Z-97
(2016)

SITE PLAN FOR
Single-Family Homes (RA-5)
#1189 Vester Drive
Landlot 962 of the 16th District
Marietta, Cobb County, Georgia

ZONING COMMENTS:

Z-97 ROYAL RESIDENTIAL, INC.

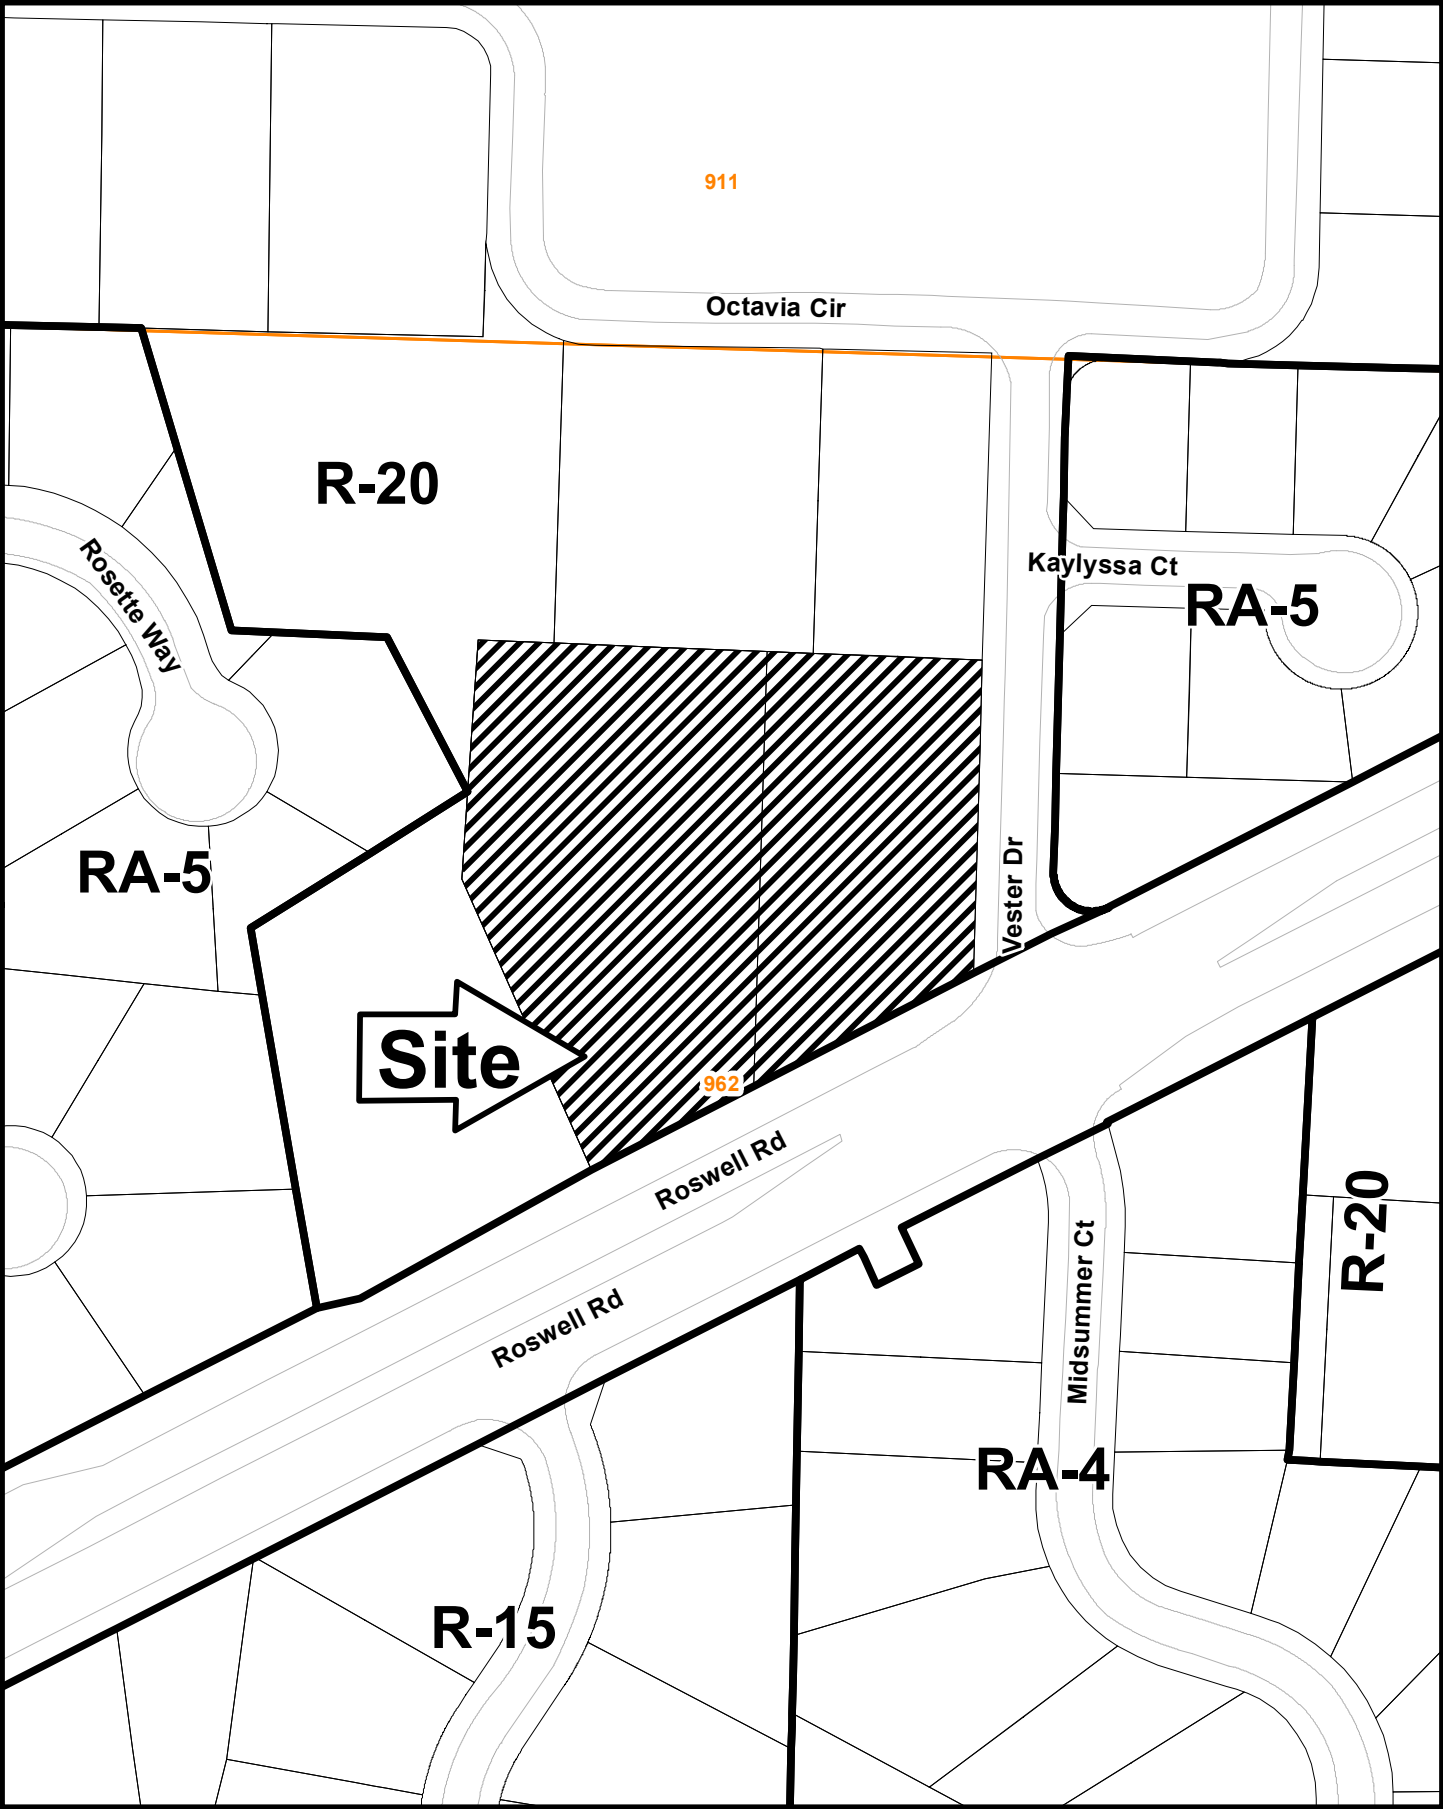
As the proposed development abuts a cemetery to the west, a cemetery buffer may be required along this side that is not shown on the current site plan. Also, a ten foot landscape buffer will be required along the northern edge where the development abuts a more restrictively zoned property.

Cemetery Preservation: Zoning petition Z-97 2016 (in land lot 962 of the 16th District) shows the presence of Antioch cemetery on the western border of the project. The Cobb Cemetery Preservation Ordinance and the County Development Standards for Cemeteries call for:

- A. Prepare a site plan identifying the full boundaries with a metes and bounds description.
- B. Provide a fifty (50) foot undisturbed natural buffer from the common property line; or a fifty (50) foot undisturbed natural buffer around the perimeter of the outermost burials of the cemetery; whichever provides the greatest protection for the cemetery.

1. This site is located at the northwest intersection of Roswell Road and Vester Drive. Approximately one quarter of the site is currently occupied by a 0.5 acre lake that is located in the center of the parcel. The storage effect of this lake provides a stormwater mitigating benefit for downstream property owners that must be maintained or recreated within this redevelopment.
2. The proposed layout will also need to accommodate an adequate drainage system to convey the existing upstream runoff through the site. This will require a 20-foot drainage easement along the rear of Lot 4 and between Lots 3 & 4.

Recommend entrance be located a minimum of 50 feet from the intersection of Vester Drive and Roswell Road.

- 1. Maximum of three (3) units per acre;
- 2. Site plan to be approved by the District Commissioner;
- 3. Code-required ten foot landscape buffer adjacent to northern neighbors to be reviewed and approved by County Arborist;
- 4. Cemetery Preservation Commission comments and recommendations;
- 5. Water and Sewer Division comments and recommendations;
- 6. Stormwater Management Division comments and recommendations; and
- 7. Department of Transportation comments and recommendations.
